County of Hawaii
PLANNING DEPARTMENT

December 7, 2007

Ohana Dwelling Unit Permit Application (OHD-07-000105)
Applicant(s): Carl N. Nakayama and Shyran K. Nakayama
Land Owner(s): Carl N. Nakayama and Shyran K. Nakayama
Proposal: Construct A Detached Ohana Dwelling Unit
Tax Map Key: (3) 2-4-010:124

PLOT PLAN

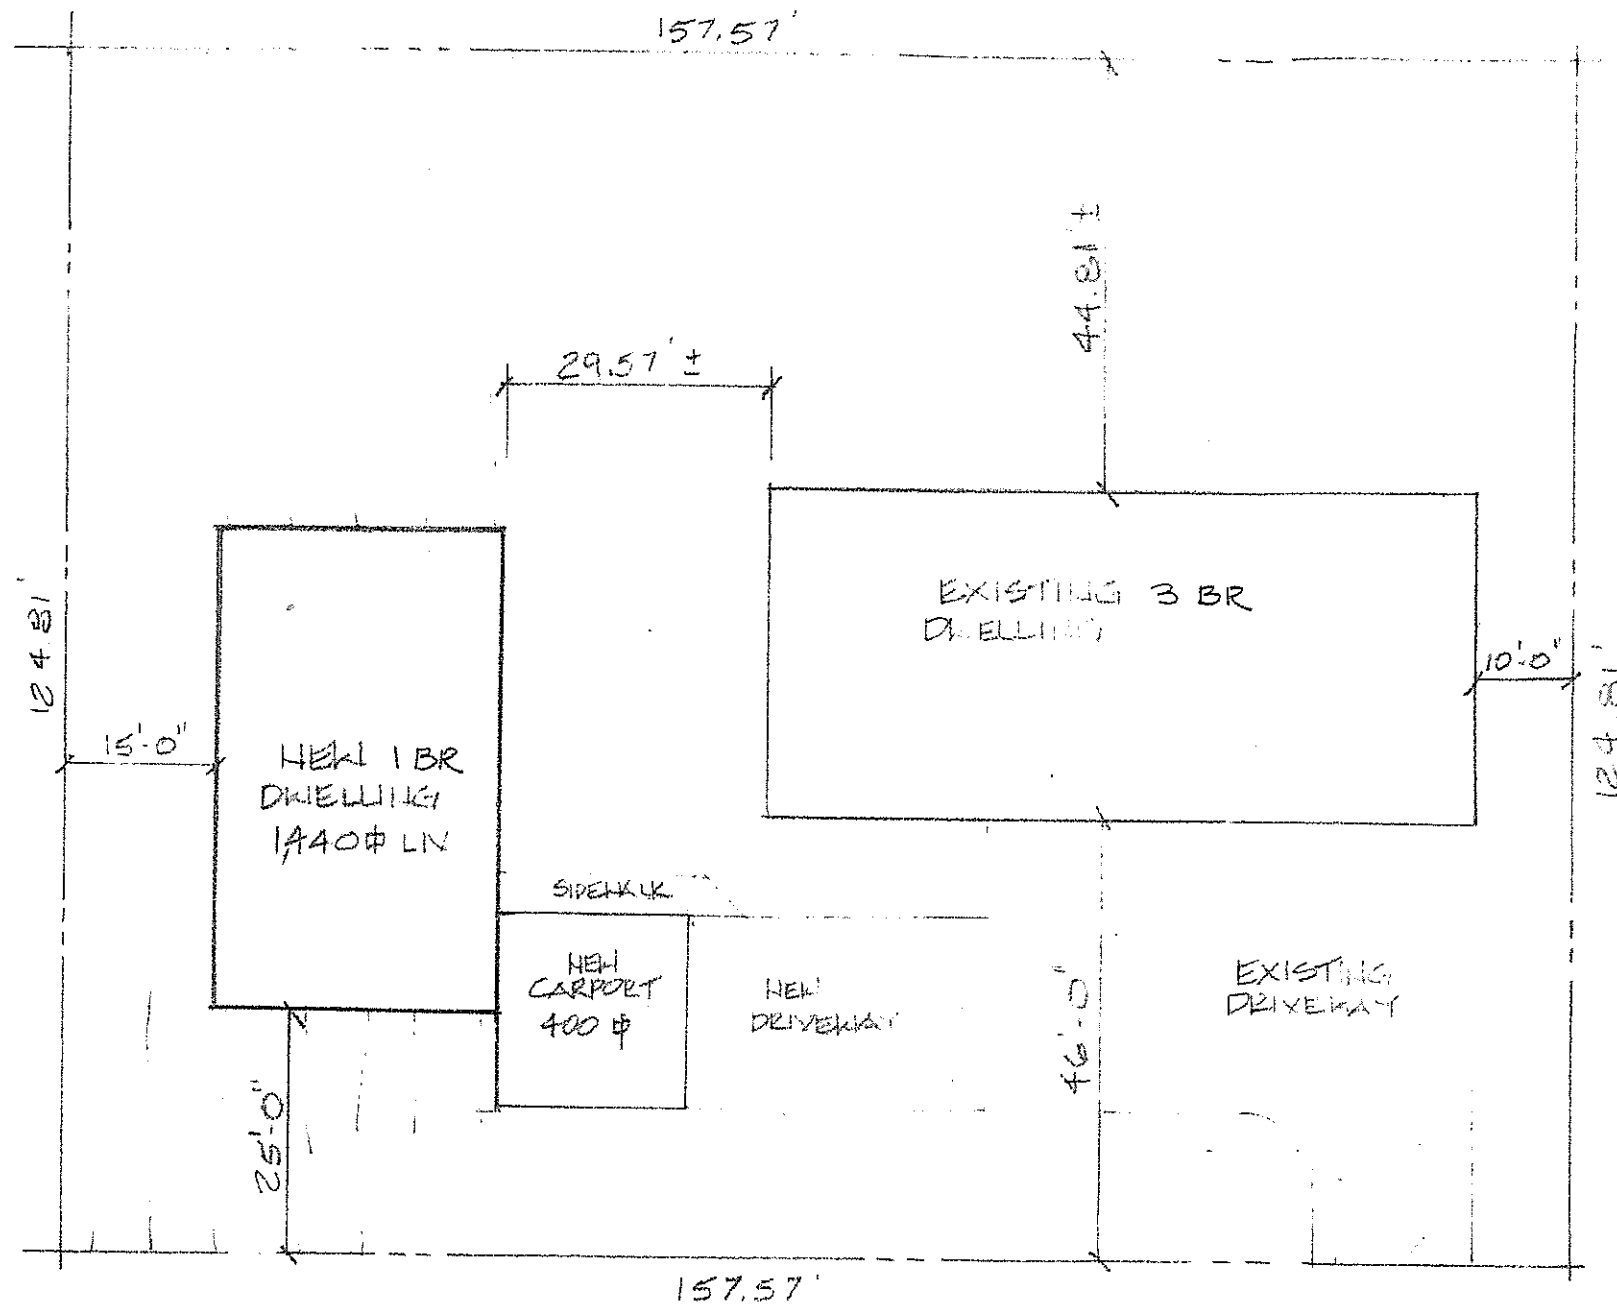
Portion of the subdivision is located within 1,000 ft. of a public water source. You are required to show the 1,000 ft. radius from the water source on the site plan. No cesspool can be installed within this 1,000 ft. radius. Within the 1,000 ft. radius, an aerobic treatment unit system may be required for sewage treatment.
